STAFF REPORT

SUBJECT: FP-2021-0059
Southridge South No. 1

Final plat consisting of 76 single-family residential building lots and 8 common lots on 16.99 acres of land in the R-8 zoning district for the first phase of Southridge South Subdivision.

C. Landscape Plan (date: 11/17/2021)

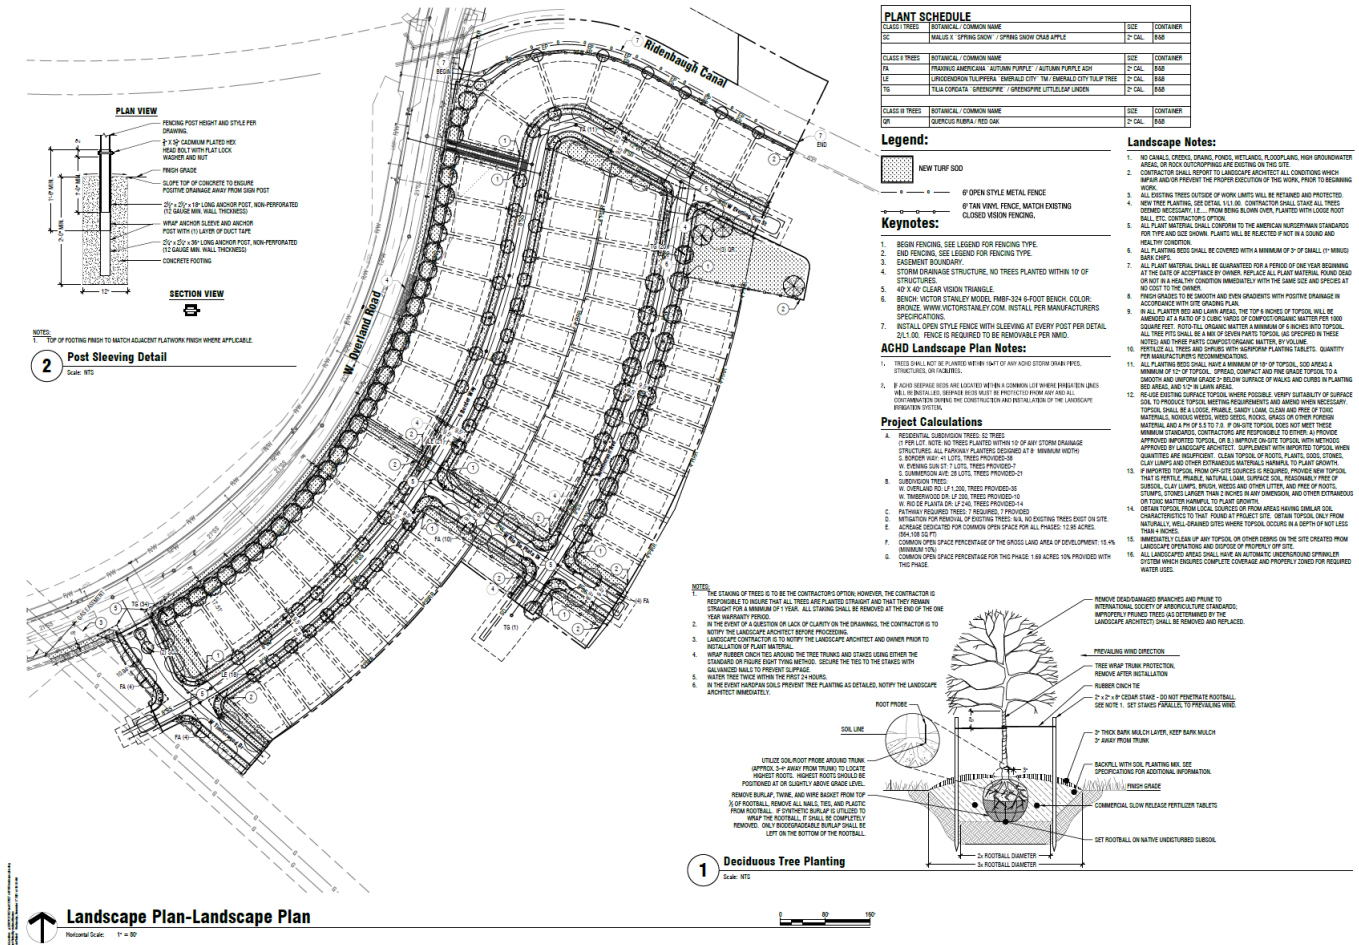
5. The landscape plan shown in Section V.C, dated 2/7/20, shall be revised as follows:
 - a. Depict shrubs (along with the proposed trees) within the street buffer along W. Overland Rd. as set forth in UDC [11-3B-7C.3a](#) per preliminary plat condition #4a.

- b. Landscaping shall be depicted along *all* pathways in accord with the standards listed in UDC [11-3B-12C](#); include a *mix* of trees (minimum of 1 per 100 linear feet of pathway), shrubs, lawn, and/or other vegetative groundcover per preliminary plat condition #4b. *If landscaping (trees) is not allowed within NMID's easement for the Ridenbaugh Canal, an additional minimum 5-foot wide area shall be provided outside of the easement in a common lot(s) for the required trees.*

- c. Correct Project Calculations table for residential subdivision (i.e. parkway) trees – a minimum of one tree is required per 35 linear feet of parkway as set forth in UDC [11-3B-7C](#), excluding 26 feet for curb cuts to each residential lot (the requirement is not one per lot as stated). Include linear feet of pathway; required number of residential subdivision trees; and common open space area and required vs. proposed number of trees that demonstrate compliance with code requirements per preliminary plat condition #4d.

- d. The fencing type along the Ridenbaugh Canal shall be black wrought iron as required by City Council; depict accordingly.
